McFarlane Aviation Products

Service Bulletin SB-6 Rev. A

August 13, 2014

SUBJECT

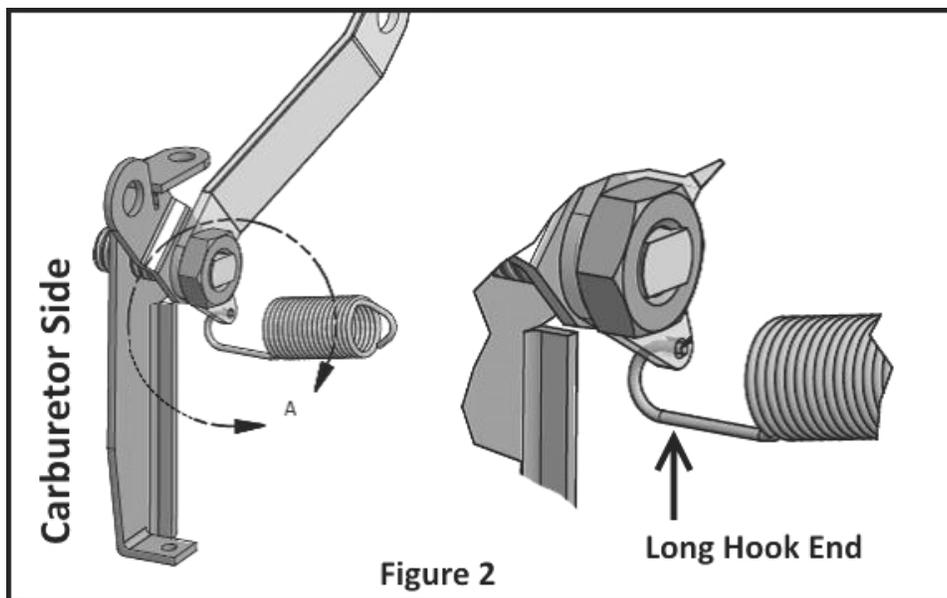
3. Install the new spring.
 - a. The long hook end of the spring is attached to the throttle linkage arm and must be oriented such that the hook end is facing away from the carburetor (Figure 2).

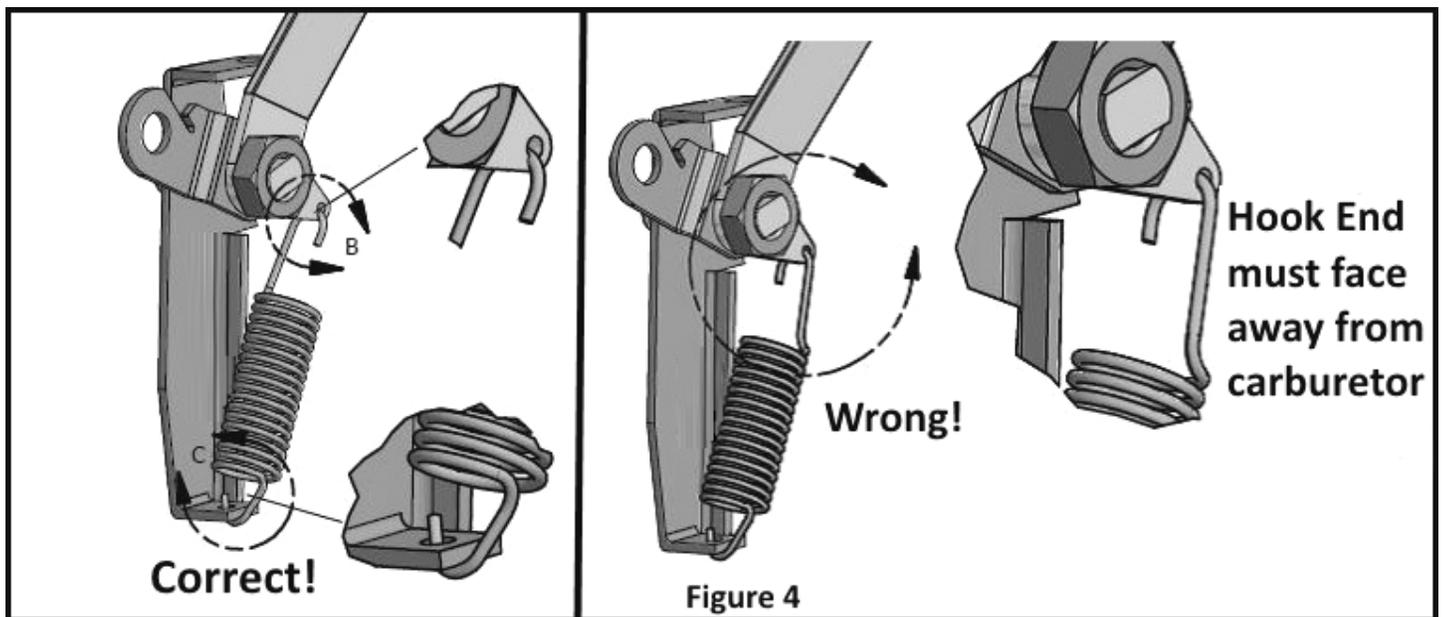
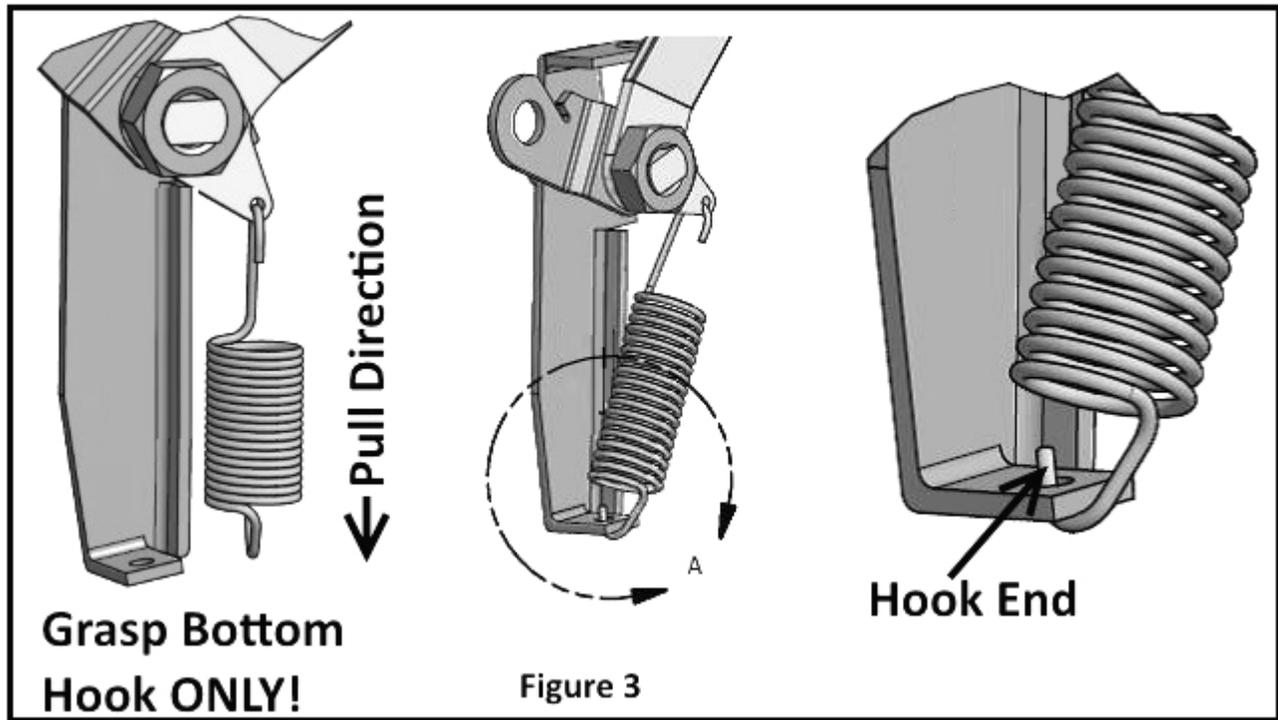
- b. Using only your hand, grasp ONLY the bottom hook and attach it to the fixed linkage. The hook end should be facing toward the carburetor body as shown in Figure 3. DO NOT TWIST the bottom hook during installation; doing so may severely limit the longevity of the spring. Correct installation position is shown in Figure 4.
